Please find enclosed three (3) copies each of Project Interface Documents (PID), 09-S-20, and 09-S-21 for the Mexican Hat, Utah, Uranium Mill Tailings disposal cell design. These PID's address design changes relating to erosion protection and bedding gradations respectively.

PROJECT INTERFACE DOCUMENT (PID)

Subject Bedding Material Gradation

Subject Revise Grading and Erosion Protection Plan for the Tailings Embankment Final Configuration and Add Requirements for Test Section and Source for Type B1 Riprap.

EROSION PROTECTION PLAN
NOT TO SCALE

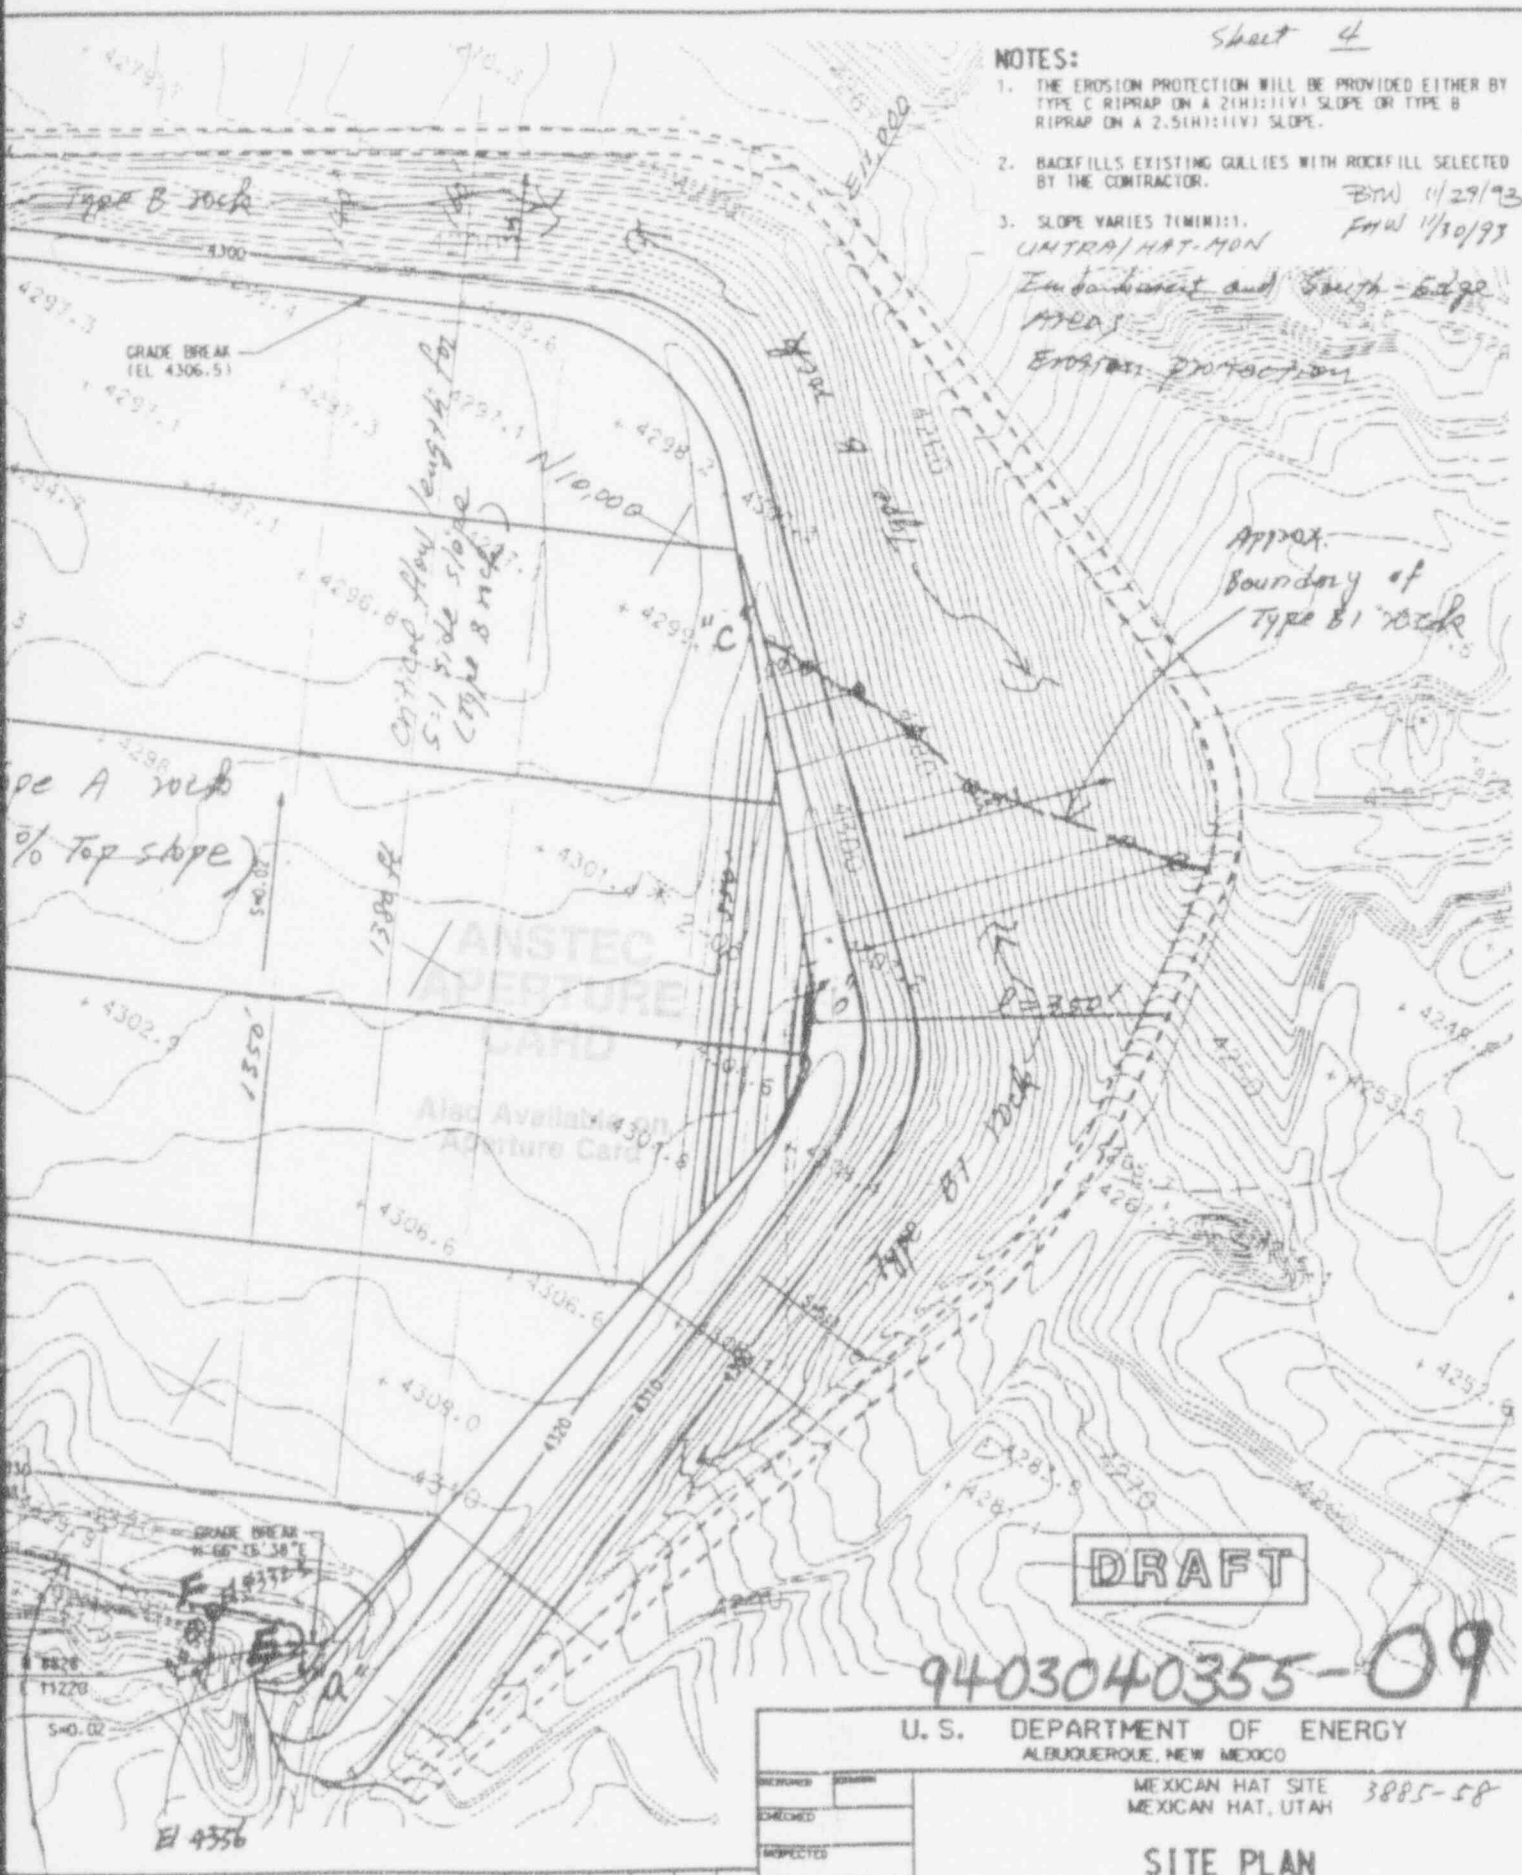
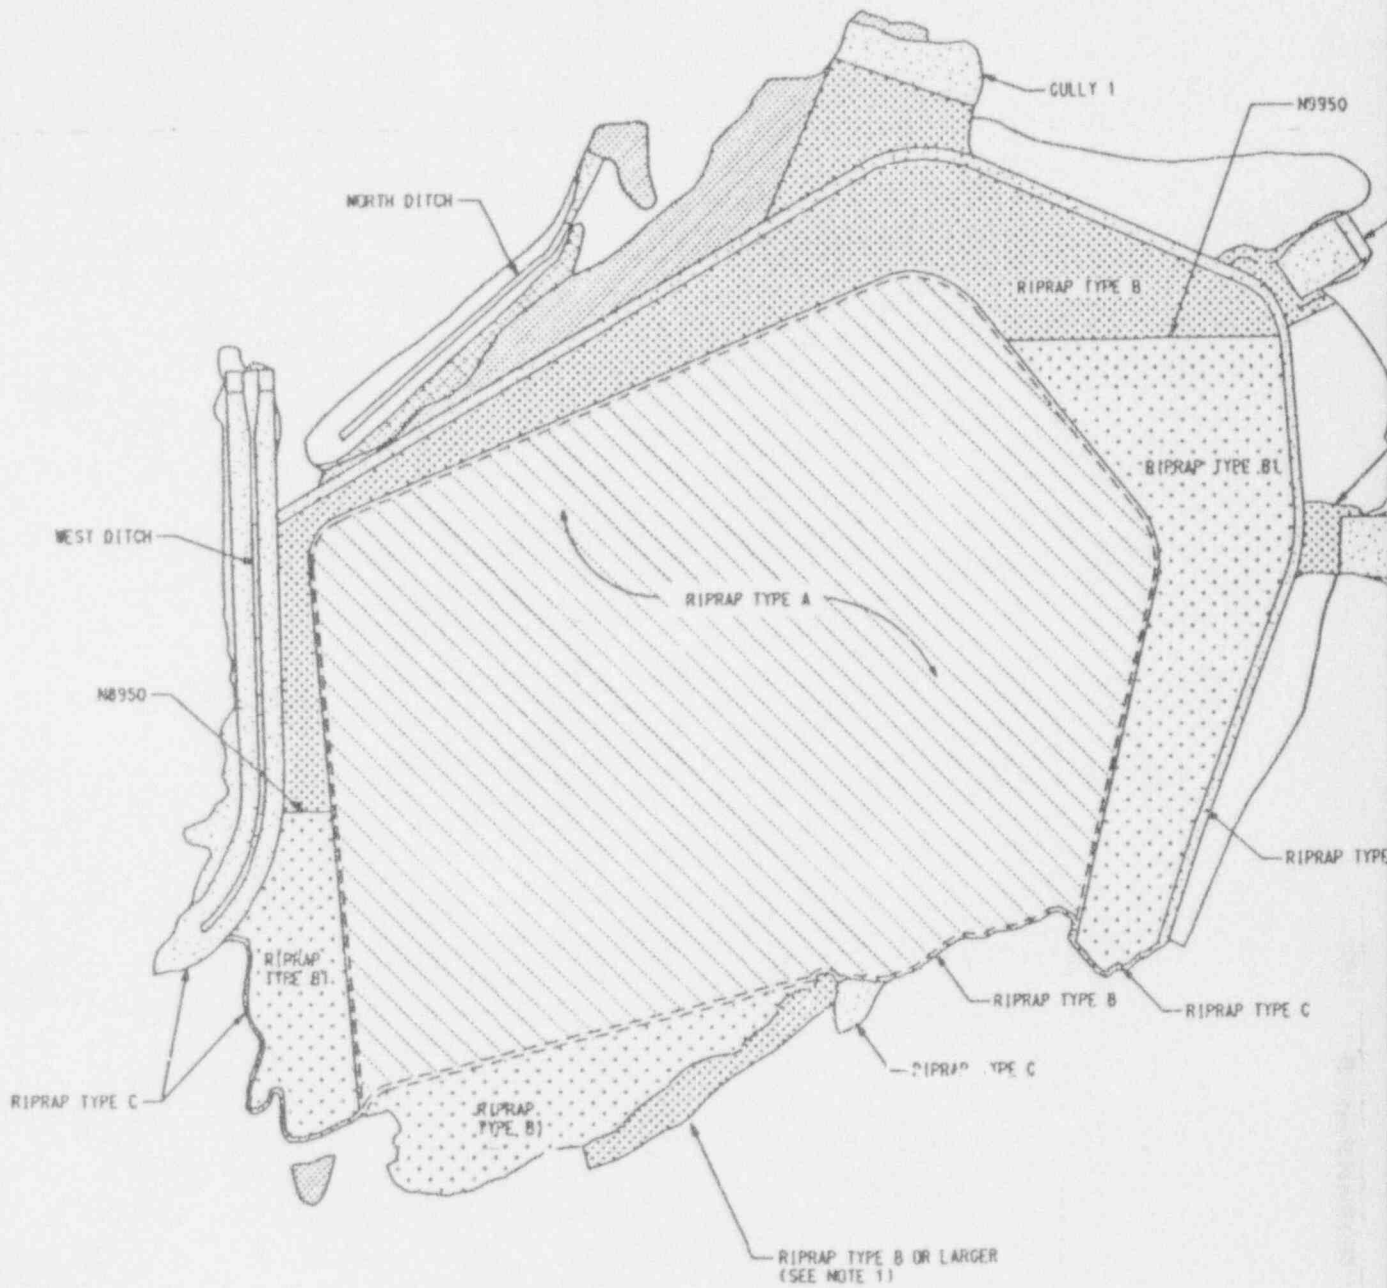
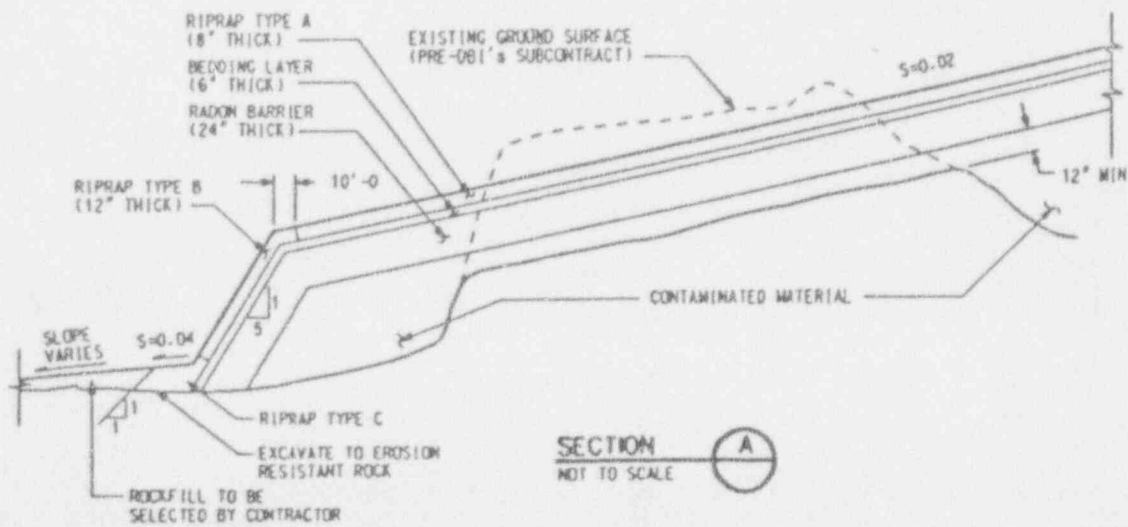
of the Type B1 riprap to be placed and the erosion protection plan and details along the south edge of the tailings embankment shall also be revised as shown on Sketch 2 and corresponding markups of Subcontract Drawings H/M-DS-10-0213, -0215, -0216 and -0219 as attached. The calculation for the proposed erosion protection design is attached (Calculation No. 9-418-14-00).

- NOTES:**
1. THE EROSION PROTECTION WILL BE PROVIDED EITHER BY TYPE C RIPRAP ON A 2(H):1(V) SLOPE OR TYPE B RIPRAP ON A 2.5(H):1(V) SLOPE.
 2. BACKFILLS EXISTING GULLIES WITH ROCKFILL SELECTED BY THE CONTRACTOR.
 3. SLOPE VARIES (1MIN):1.
- UNTRA/HAT-MON
 Embankment and South-Edge Areas
 Erosion Protection
